**HISTORIC PRESERVATION COMMISSION
MEETING AGENDA**

BUTTE-SILVER BOW HISTORIC PRESERVATION COMMISSION CERTIFICATE OF APPROPRIATENESS (COA) APPLICATION

Address: 668 S. Montana St.
Addition/Block/Lot: Welcome Stranger/Block 4/South Part Lot 6
Other Legal Description:

1959 photograph of 668 S. Montana St. From tax assessment card, on file Butte-Silver Bow Public Archives.

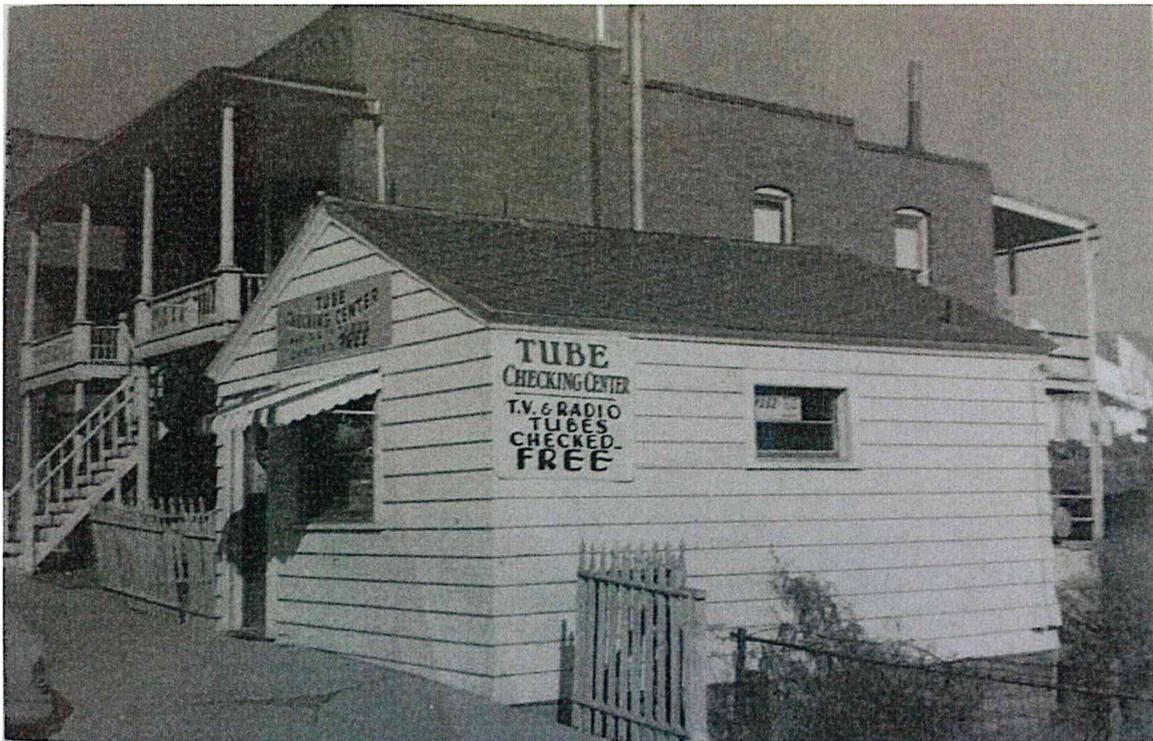
[HPO Comments: The front porch clearly retained is original qualities of design and materials when the first tax assessment photographs of the building were taken in 1959 (see attached photographs). Typical of Butte's walk-up flats it was an open, full length two-story porch with an exterior staircase providing access to the upper story. The staircase was at center and featured a single set of stairs from the ground level to an intermediary landing. Sets of stairs then ascended from both sides (north and south) of landing, or branched into a Y, with each set leading to a porch at one of the upper story apartments. A low hip roof covered the upper story porch. The porch was distinguished by slender round column supports and turned post balustrades at both the lower and upper stories. The column supports stood on square pedestals and were capped by simple capitals, and ball finials adorned the newel posts. The 1985 historic property form and photograph for this property (see attached), reveal that the

porch retained most of its round columns and turned post balustrade at that time. Google Map's 2012 photograph of the building showed just two of the round column supports still standing, both at the lower story].

[HPO comment: The 1959 photograph reveals that the building's original front doors were standard half-light doors with five cross panels below the window. Those doors look to have been still intact as of the 1985 inventory. It's possible that the "exiting doors," were the building's original back doors, relocated to the front of the building after 1985].
